## MEMORANDUM

**TO:** PLANNING COMMISSION  
**FROM:** KEN ONDICH, PLANNING / COMMUNITY DEVELOPMENT DIRECTOR  
KYRA CHAPMAN, PLANNER  
**SUBJECT:** REQUEST FOR PRELIMINARY AND FINAL PLAT REVIEW OF POND  
THIRD ADDITION CONSISTING OF 4 LOTS ON 2.43 ACRES IN THE RL-90  
SINGLE FAMILY RESIDENTIAL ZONING DISTRICT, AS PROPOSED BY  
MICHAEL WEINANDT, APPLICANT.  
**DATE:** 10/18/23

PRELIMINARY PLAT

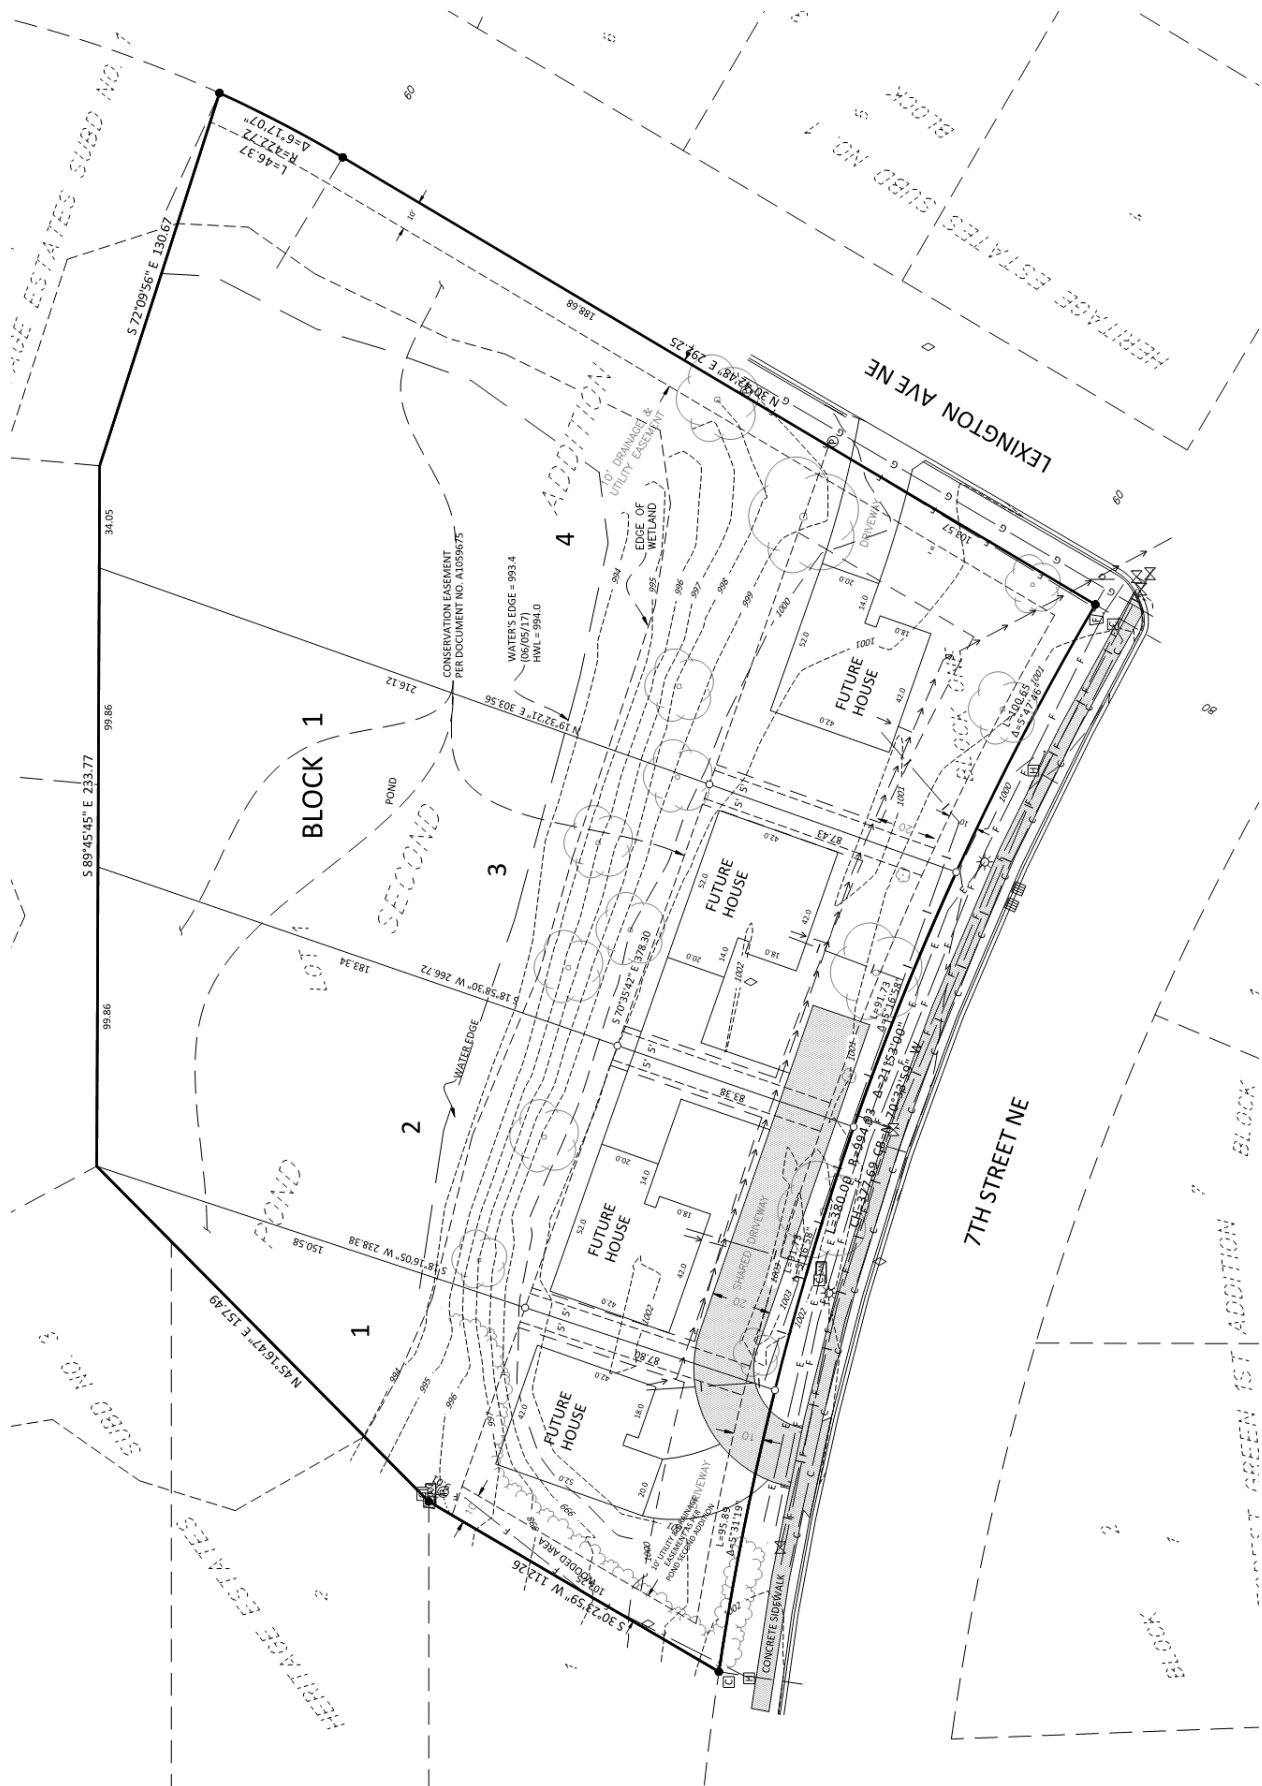
Any driveway area in front of future garages must be at least 22' in length to accommodate a vehicle parking between the garage door and the edge of the private driveway. All proposed driveways appear to provide for a 22' length except for the proposed home on lot 1. This home must be pushed back to 6' from the conservation easement to provide for a minimum 22' driveway length to the private drive.

1. Redundant perimeter control will be needed on the north side of the site (silt fence most likely) along the conservation easement.
2. It appears the shared driveway will drain into a swale east of the entrance and then over the sidewalk. They are cutting out enough soil (1-2ft) that trees will need to be removed and likely the transformer and light would be impacted. It will also concentrate flow and likely be an icing issue over the sidewalk.
3. Information on the driveway would be helpful, but not required.
4. The driveway apron on Lexington Avenue shouldn't need to be replaced as shown.
5. Construct sidewalk along Lexington Avenue?

6. The NW corner appears to show tree line impact with grading. I can't verify if that's just tree trimming or would potentially impact trees in the conservation easement.
7. Information on sewer/water services as you noted. This is mostly just needing to meet plumbing code. NPU and PW will need to comment regarding other concerns.

Ideally, the building pads would be a bit higher to have positive drainage toward 7<sup>th</sup> Street NE, but I'm guessing this is the most they can do without grading past the conservation easement.

16. All homes are required to be setback at least 6' from the existing conservation easement.
  17. All homes are required to provide for driveways at least 22' in length between the garage and private access driveway.
